# UNITED STATES PATENT AND TRADEMARK OFFICE

**Office Action Summary**

## **DETAILED ACTION**

FIG. 2

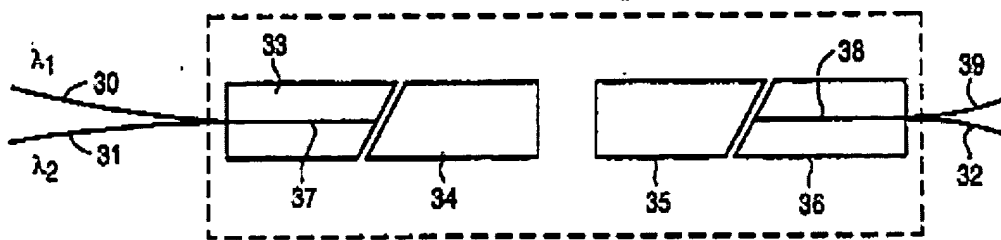
Regarding claim 10, as seen in his Figure 2 (reproduced below), Pan discloses an optical coupler comprised of at least a plurality of optical fibers (30, 31), the first device (34) disposed in optical communication with a second end of each of the optical fibers (30, 31), one second device (Fig. 20, 214) disposed in optical communication with the first end of one of the optical fibers, another second device (214) disposed in optical communication with the first end of another optical fiber, with the at least plurality of optical fibers (30, 31) having each one of its second ends placed head to head with the first device (34).

Regarding claim 11, a ferrule (33) of Pan also retains the second ends of optical fibers (30, 31).
